City of Portland, Maine – Building or Use Permit Application 389 Congress Street, 04101, Tel: (207) 874-8703, FAX: 874-8716

Location of Construction: 14 Racine Ave (12 - 18)		Owner: Baystate Development Corp		Phone:		Permit No: 960294	
Owner Address: 400-1 Totten Pond Rd Waltham, MA 02154		Leasee/Buyer's Name:		Phone:		BusinessName:	
Contractor Name: Greg Holden - 829-5352		Address:		Phone:		Permit Issued: APR 24 1996	
Past Use:] Vacant Land		Proposed Use: 1-fam dwelling		COST OF WORK: \$ 60,000.00		PERMIT FEE: \$ 320.00	
Proposed Project Description: 1-fam dwelling (24 x 44) Attached garage (14 x 24)		FIRE DEPT. <input type="checkbox"/> Approved <input type="checkbox"/> Denied		INSPECTION: Use Group: <i>A3</i> Type: <i>5B</i> <i>BOCA 93</i>		Zones: <i>R-3</i> CBL: 399-A-019	
		Signature:		Signature: <i>Hoffner</i>		Zoning Approval: <i>OK</i> <i>4/22/96</i>	
PEDESTRIAN ACTIVITIES DISTRICT (P.U.D.)		Action: <input type="checkbox"/> Approved <input type="checkbox"/> Approved with Conditions <input type="checkbox"/> Denied		Signature:		Date:

Proposed Project Description: 1-fam dwelling (24 x 44) Attached garage (14 x 24)		PEDESTRIAN ACTIVITIES DISTRICT (P.U.D.) Action: <input type="

Lot # 7

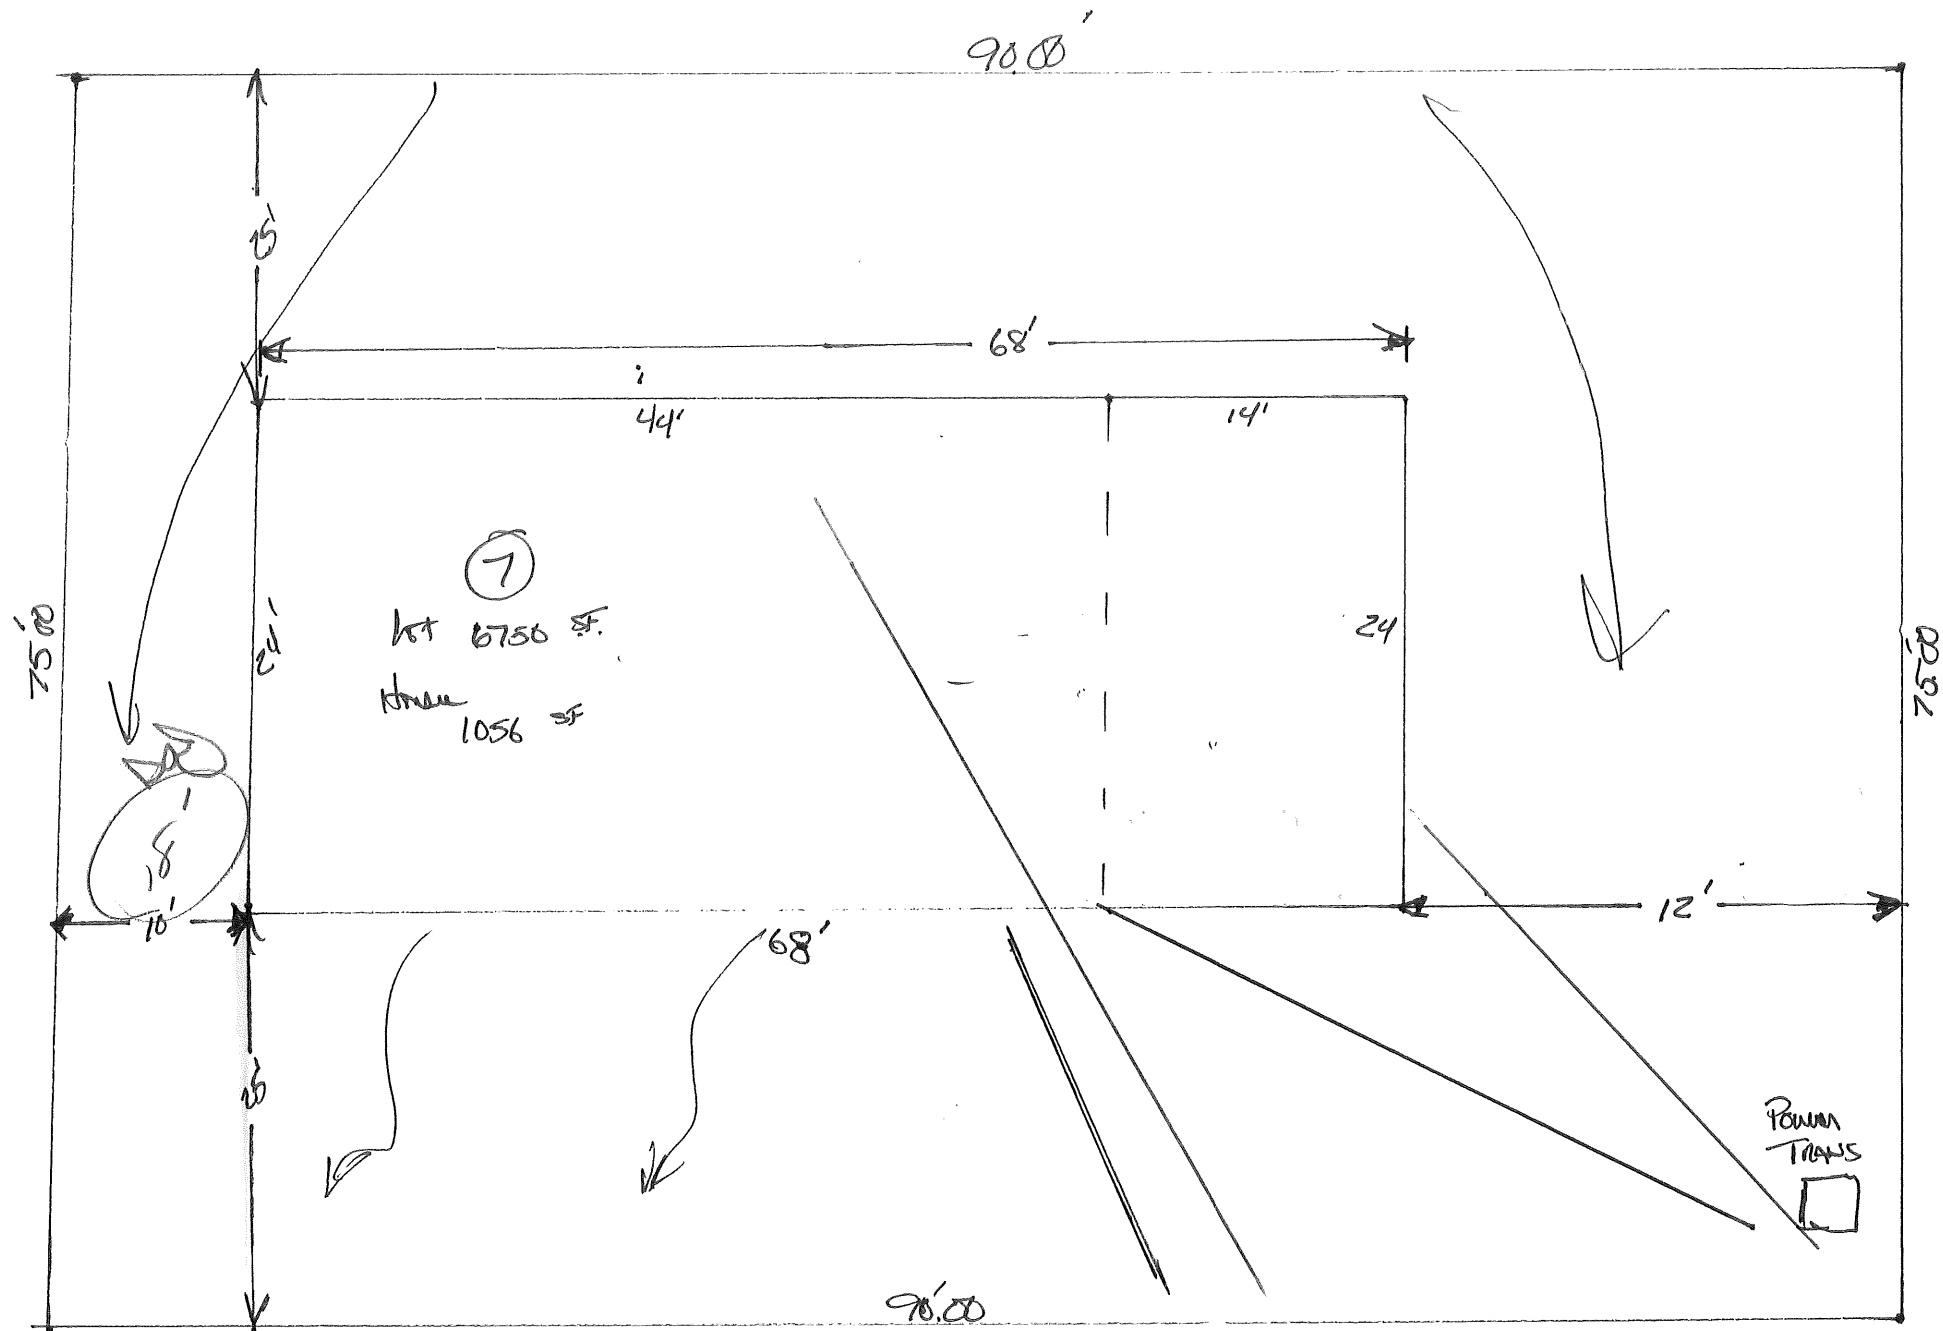
- Please see attached standard conditions.
- Contractor shall utilize existing curb cuts for driveway access.
- Finish Floor Elevation (FFE) shall be 4' higher than street elevation at the curb/gutter line.
